NUCLEAR REGULATORY COMMISSION

Title: Advisory Committee on Reactor Safeguards
Reliability and PRA Subcommittee

Date: Tuesday, June 19, 2012

The Subcommittee will hear the staff's discussion of the revised NUREG-1855 Guidance on the Treatment of Uncertainties Associated with PRAs and Risk-Informed Decision Making. We'll hear presentations from the NRC staff, their contractors and a representative from EPRI. There will be a phone bridge line. To preclude interruption of the meeting the phone will be placed in a listen-in mode during the presentations and Committee discussion.

NUREG RESTRUCTURE

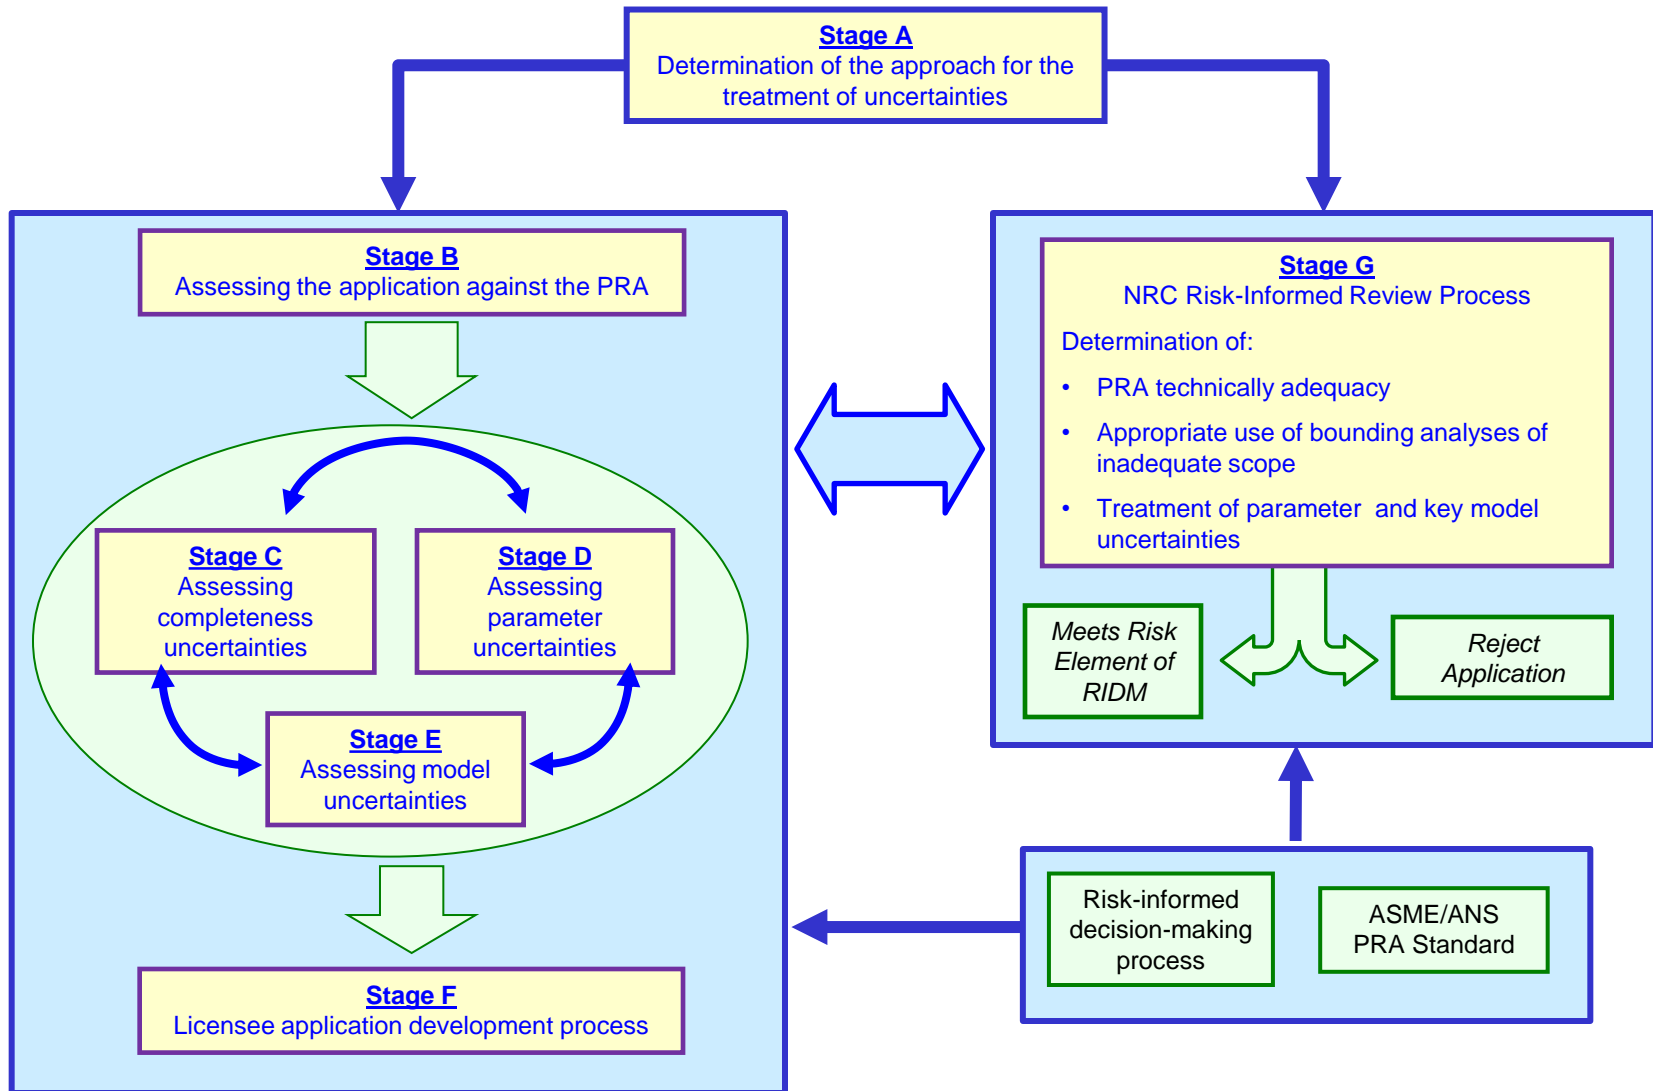
16 CHAIR STETKAR: One of the things, Mary,
17 and this is kind of, for me anyway, a fairly important
18 philosophical issue. This drawing in the NUREG draws
19 a nice, clean dotted line around what the NUREG
20 addresses. And it shows that little excerpt from
21 deterministic analyses as assessing the impact on
22 defense-in-depth and safety margins.

4 There's a drawing that's similar to this
5 in Reg Guide 1.174 that doesn't show this crisp dotted
6 line, and indeed it shows direct crosstalk between
7 deterministic analyses for safety margins and PRA
8 analyses. So the NUREG has separated that out. And
9 that's different. And that's an important difference
10 for me.

10 CHAIR STETKAR: -- but it seems to be part
11 of the philosophy of it. And this, as I said, this
12 particular drawing draws a very clear distinction that
13 isn't drawn in 1.174. You know, it just isn't.

1 fix the text to let people know this. It wasn't meant
2 to be this hard and fast rule. And I mean if we just,
3 let's go here to the example to show. You know for
4 example the risk, if we look at the Maintenance Rule
5 (a)(2). It's utilizing a risk monitor, so you're
6 constantly evaluating the risk.
